MOD2025/0157

NOTE:
NO CHANGE TO APPROVED BUILDING FOOTPRINT

LEGEND OF MODIFICATIONS:

UNDERCROFT PLAN

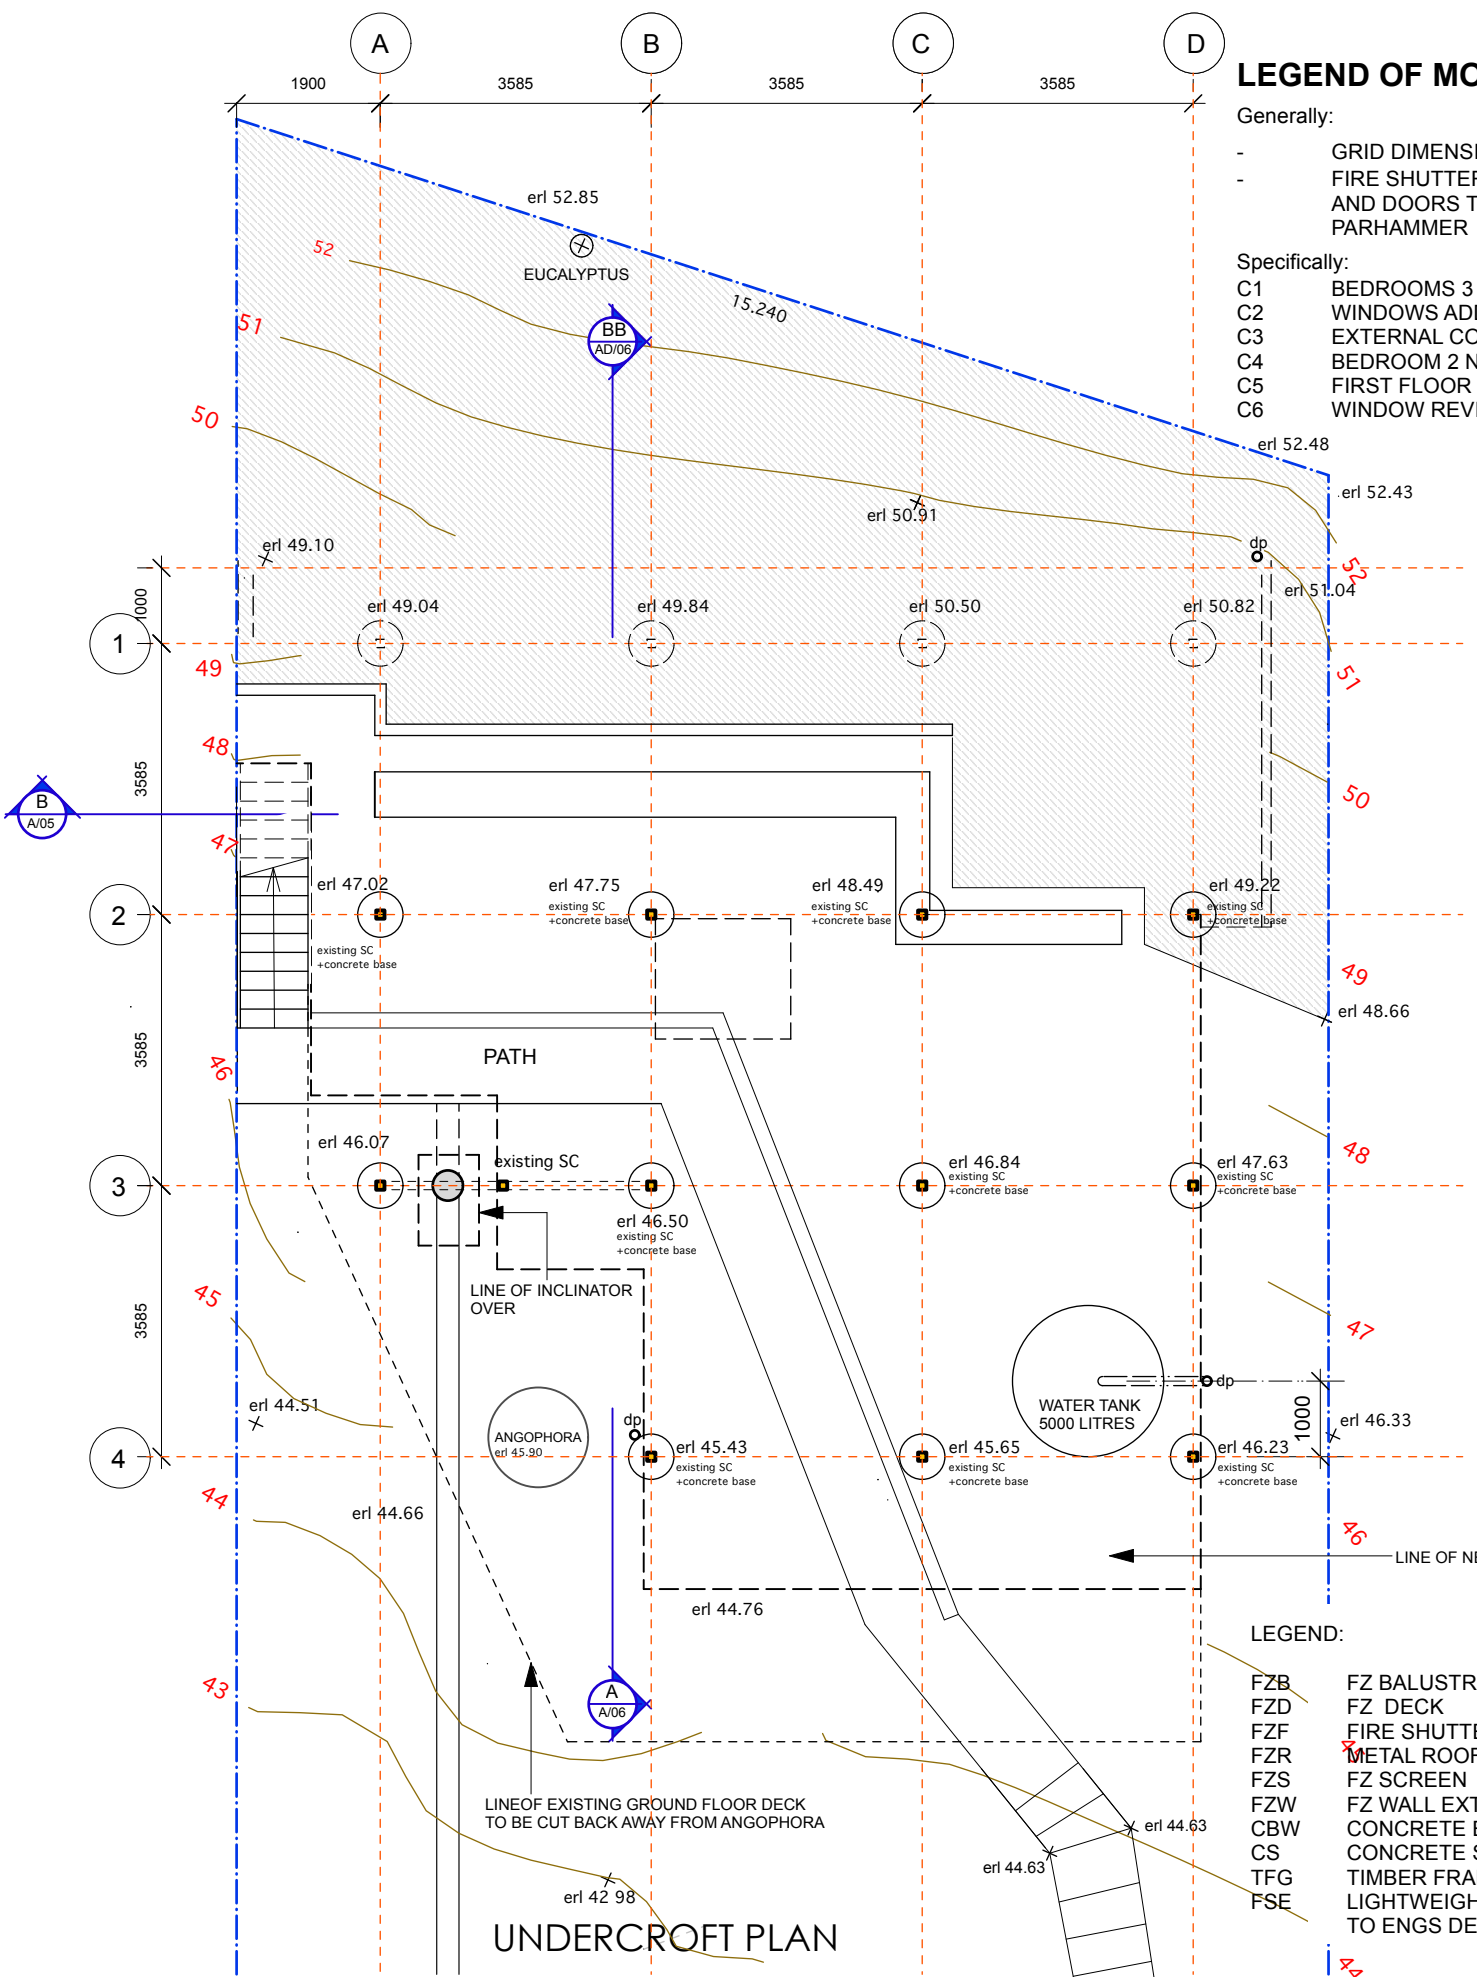
- Generally:
- GRID DIMENSIONS ADJUSTED
 - FIRE SHUTTERS DELETED AND EXTERNAL WINDOWS AND DOORS TO BE FZ RATED SIMILAR + EQUAL TO PARHAMMER
- Specifically:
- C1 BEDROOMS 3 + 4 SLIDING DOORS RELOCATED IN WALL
 - C2 WINDOWS ADDED
 - C3 EXTERNAL CORNER REVISED
 - C4 BEDROOM 2 NORTH WALL MOVED
 - C5 FIRST FLOOR DECK REVISED
 - C6 WINDOW REVISIONS

LOWER GROUND FLOOR PLAN

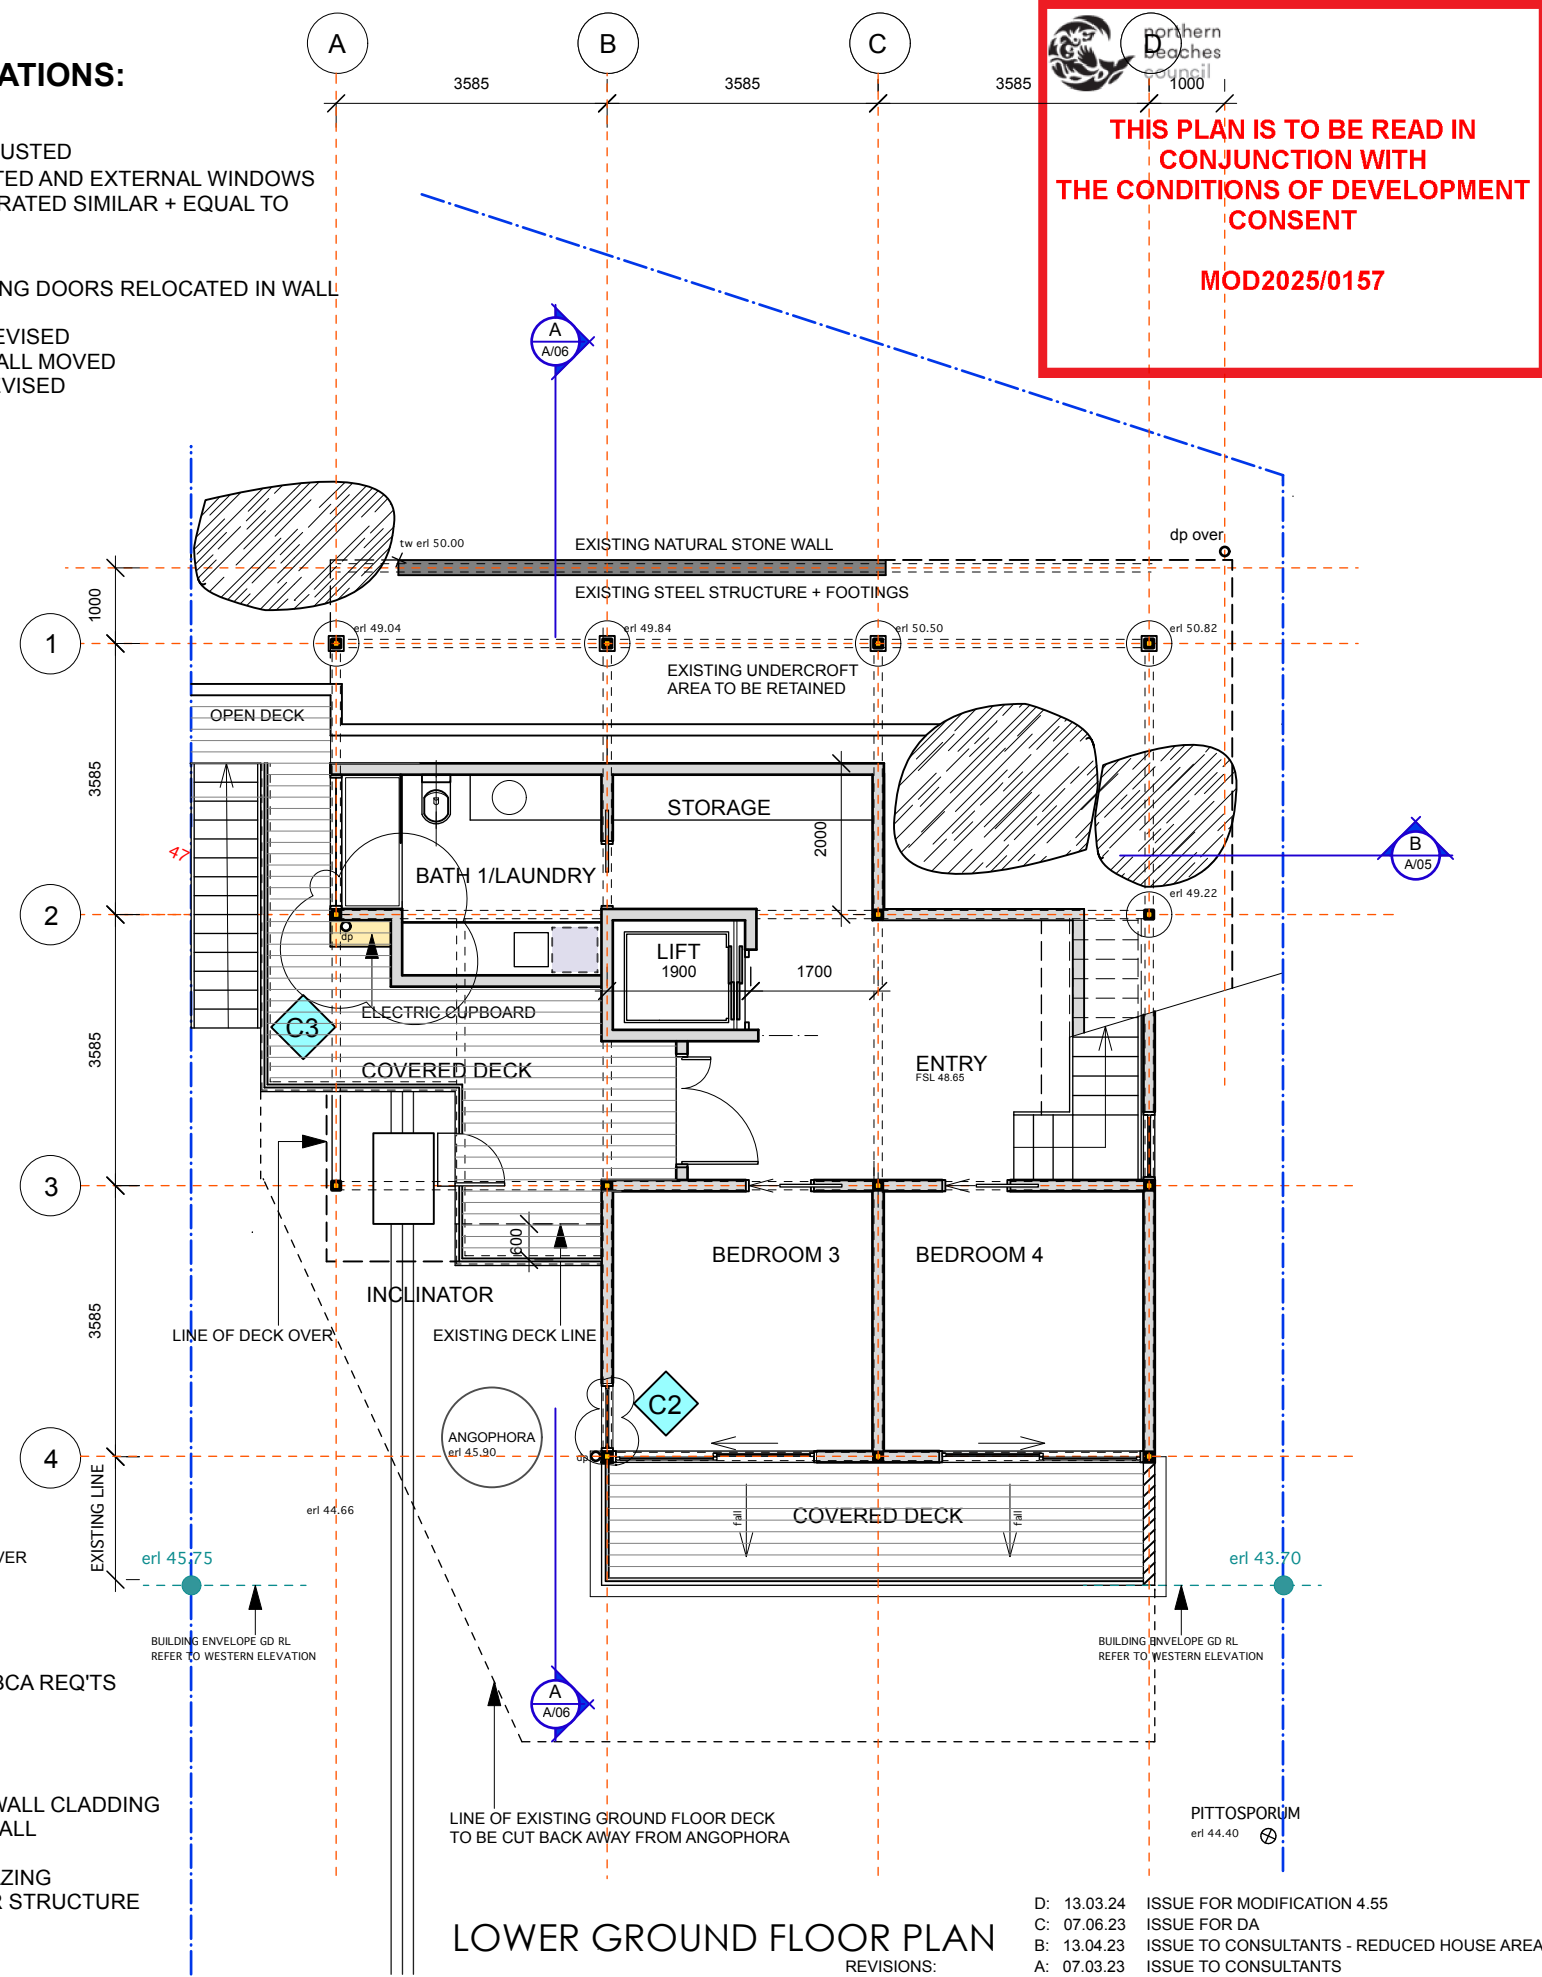
- C1 BEDROOMS 3 + 4 SLIDING DOORS RELOCATED IN WALL
- C2 WINDOWS ADDED
- C3 EXTERNAL CORNER REVISED
- C4 BEDROOM 2 NORTH WALL MOVED
- C5 FIRST FLOOR DECK REVISED
- C6 WINDOW REVISIONS

WEST ELEVATION

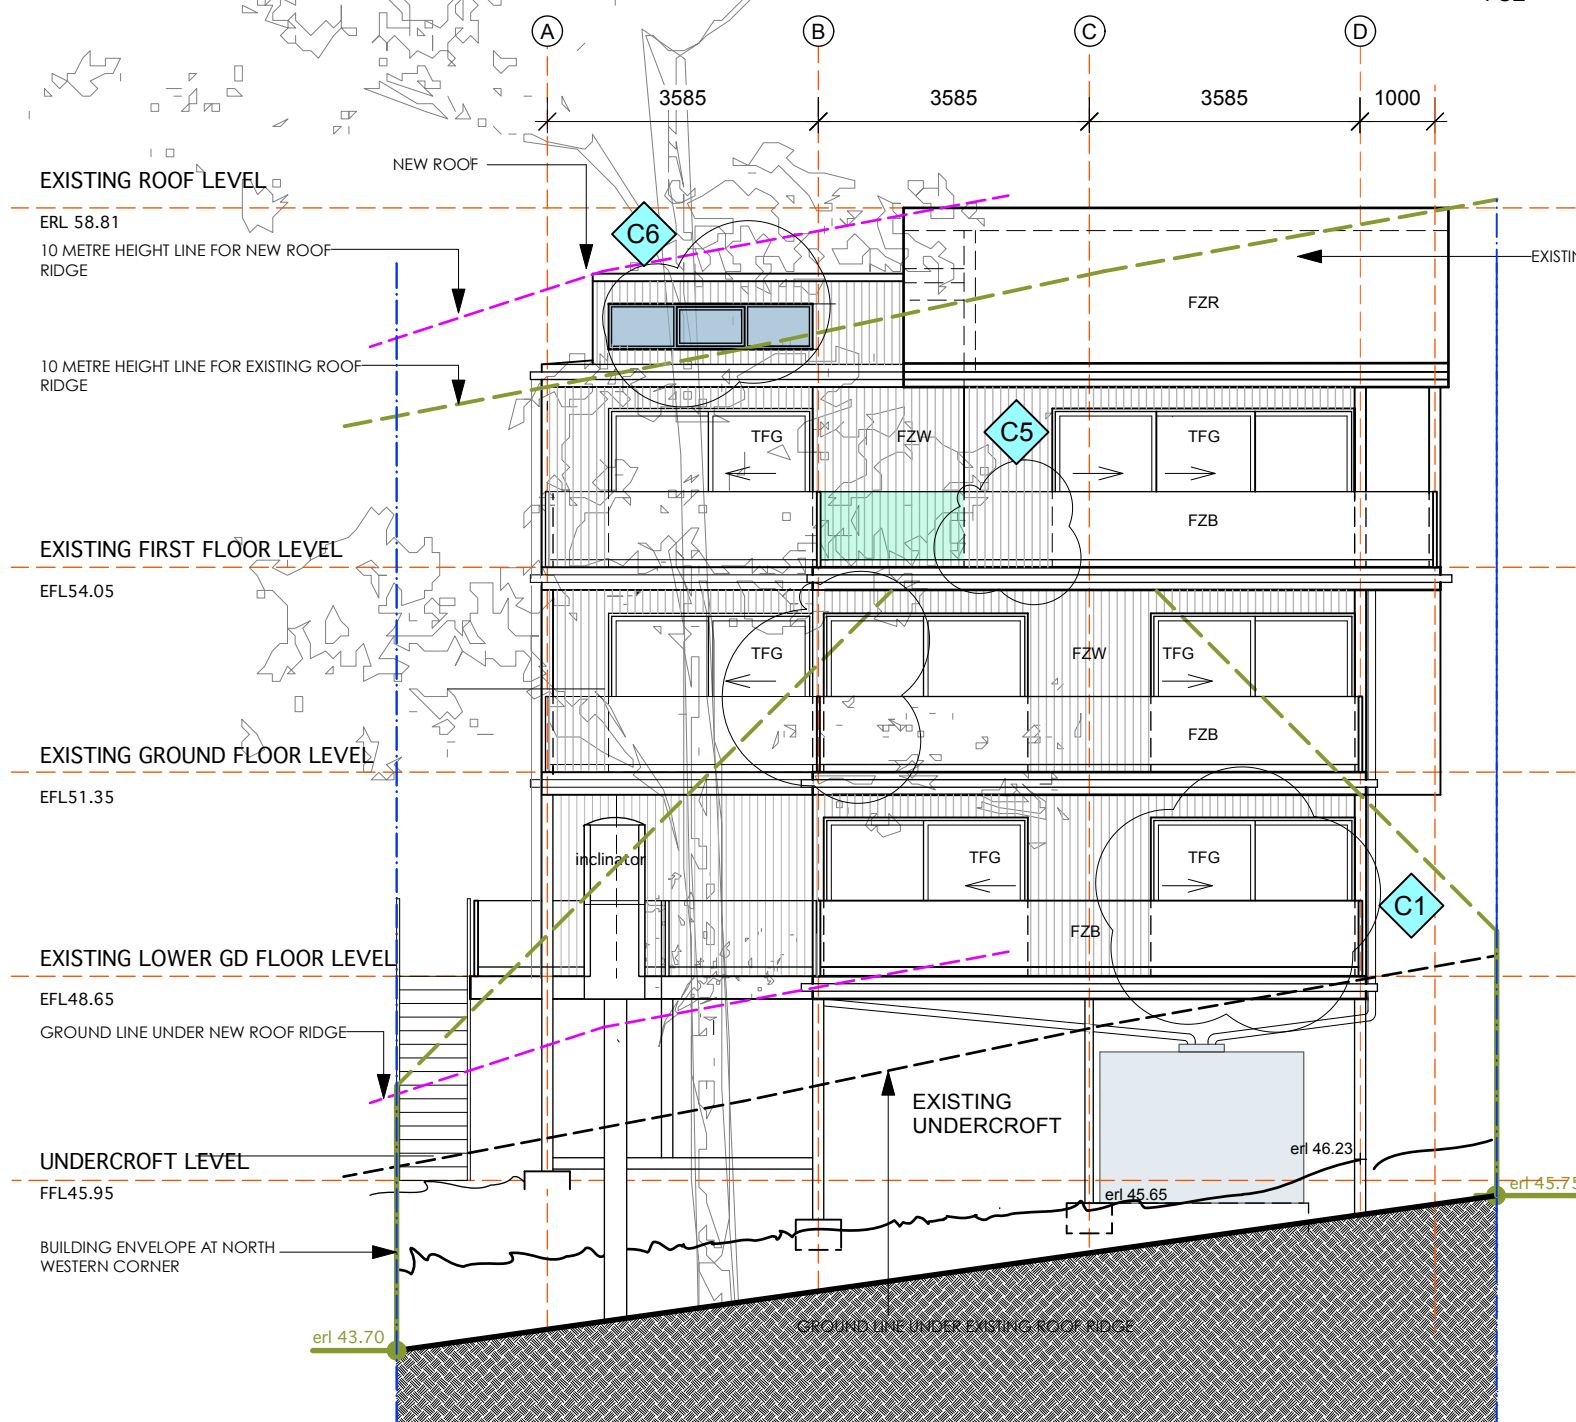
- C1 BEDROOMS 3 + 4 SLIDING DOORS RELOCATED IN WALL
- C2 WINDOWS ADDED
- C3 EXTERNAL CORNER REVISED
- C4 BEDROOM 2 NORTH WALL MOVED
- C5 FIRST FLOOR DECK REVISED
- C6 WINDOW REVISIONS
